Friday, September 16, 2022

Design Review Cases

FW2022-012 – West 73rd Street Apartments New Construction:

FW2022-016 – West 65th Street Apartments New Construction:

North Building West Elevation

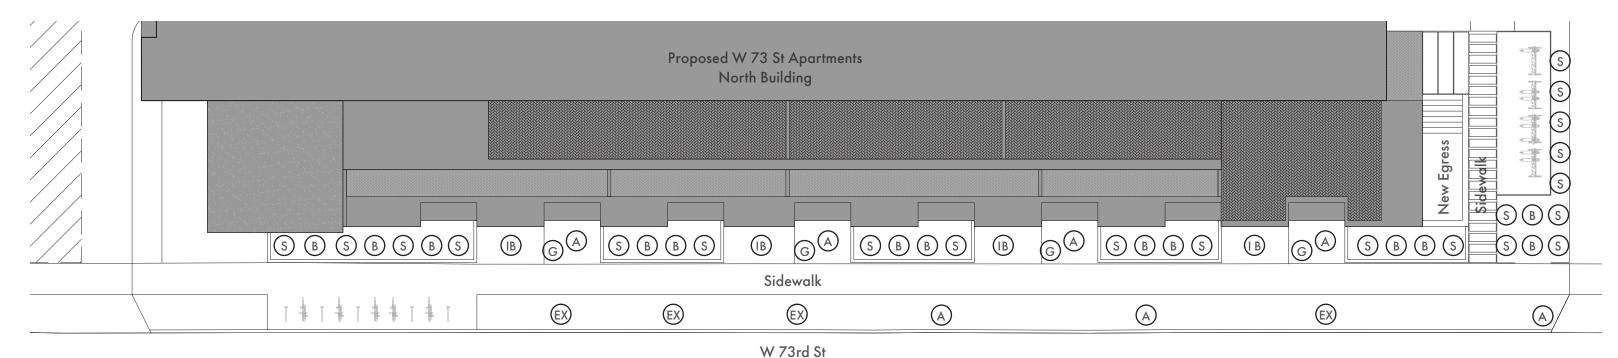
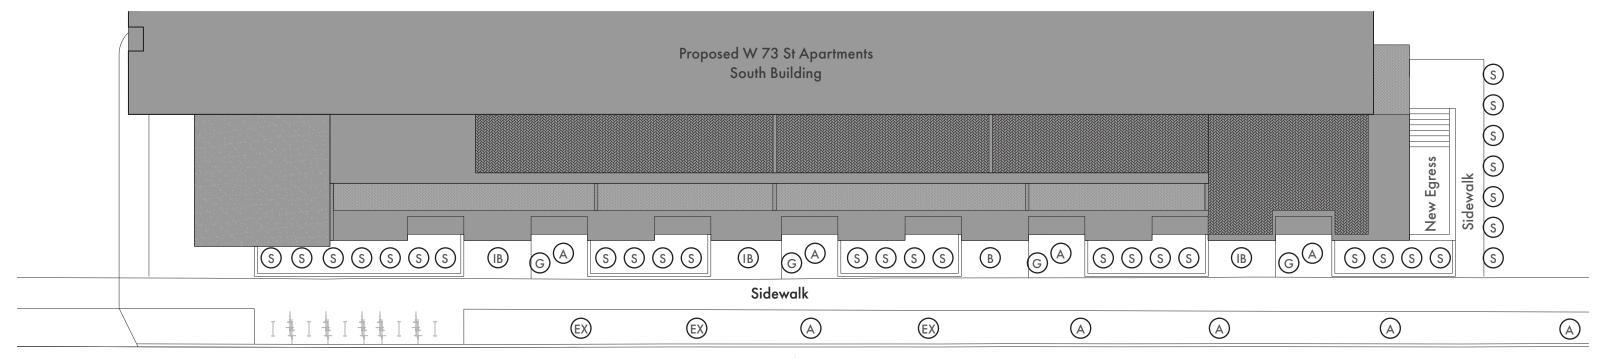
- 1. Evaluate 4th floor EFIS can this be a different material (metal panel)?
- 2. Bring out 4th floor balconies to soften upper massing
 - a) 1st floor balconies need to be wood framed per drainage issues
- 3. Differentiate brick patterns if possible near balconies and other defining elements
- 4. Evaluate if blank wall above vestibule can be broken up with public art or a green wall element, etc.

- 1. Evaluate 4th floor EFIS can this be a different material (metal panel)?
- 2. Bring out 4th floor balconies to soften upper massing
 - a) 1st floor balconies need to be wood framed per drainage issues
- 3. Differentiate brick patterns if possible near balconies and other defining elements
- 4. Evaluate if blank wall above vestibule can be broken up with public art or a green wall element, etc.
- 5. Minimize drop off areas and be careful about the defining streetscape elements, clearly delineating where scooter parking, bike parking, and ride share elements are located.
- 6. Landscaping plan will be required for final review
- a. Define greenspace in between buildings and define it more as a special element of the project

Site Plan

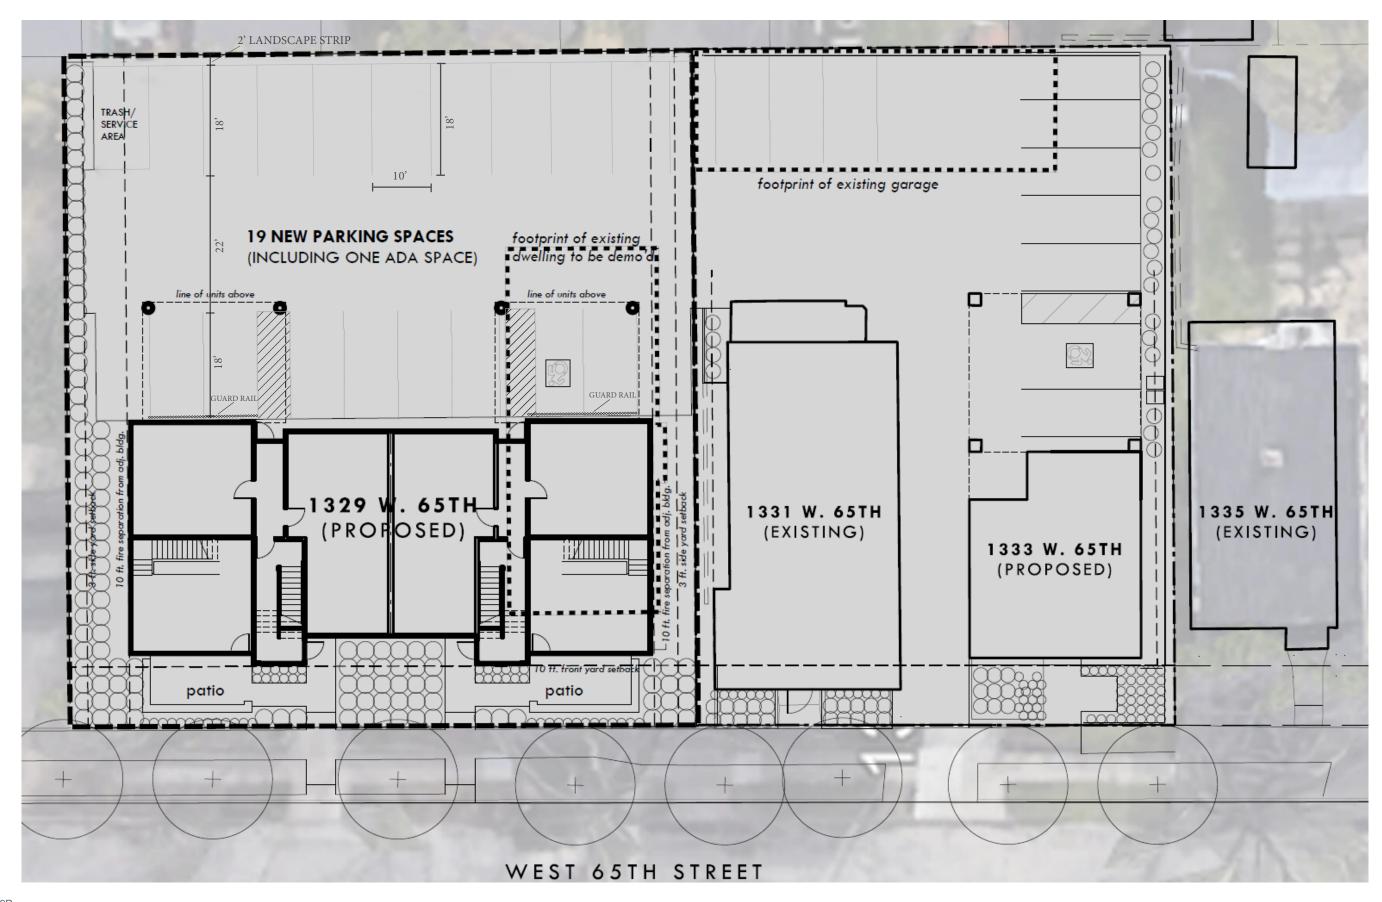
- 1. Request for tree preservation plan and a noted site plan of what is/is not being saved on the site.
- 2. Evaluate if trash area can be moved to a mid-point on the site to allow for a greater landscaping buffer along the rear
- 3. Enhance the landscaping on the rear (east side) of the site
- Rear façade needs to broken up and articulate more this façade looks at multiple houses on W.
 64th Street

- 1. Request for tree preservation plan and a noted site plan of what is/is not being saved on the site.
- Evaluate if trash area can be moved to a mid-point on the site to allow for a greater landscaping buffer along the rear
- 3. Enhance the landscaping on the rear (east side) of the site
- 4. Rear façade needs to broken up and articulate more this façade looks at multiple houses on W. 64th Street

GOLD COAST LOFTS | GLENVILLE, CLEVELAND, OHIO | LANDSCAPE CONCEPTS

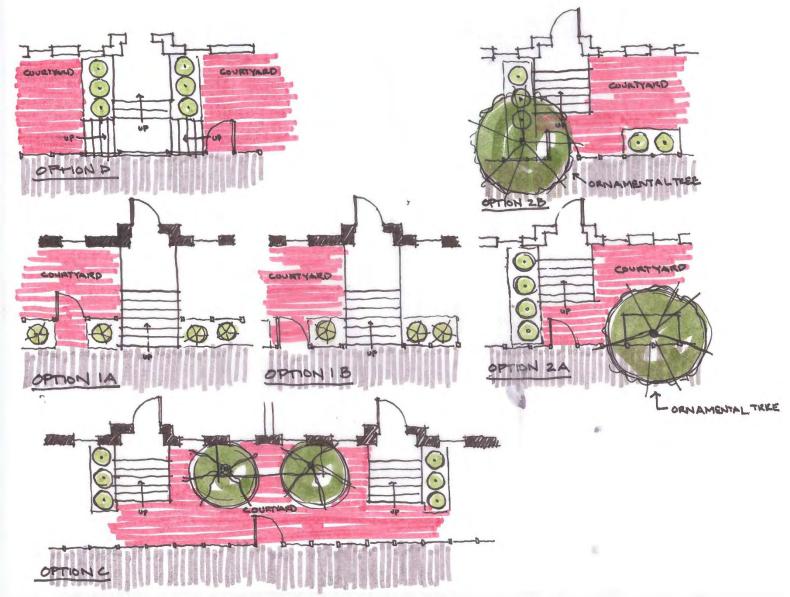
1. Insure that landscape treatment at corner specify type and height of materials & confirm whether irrigation will be included.
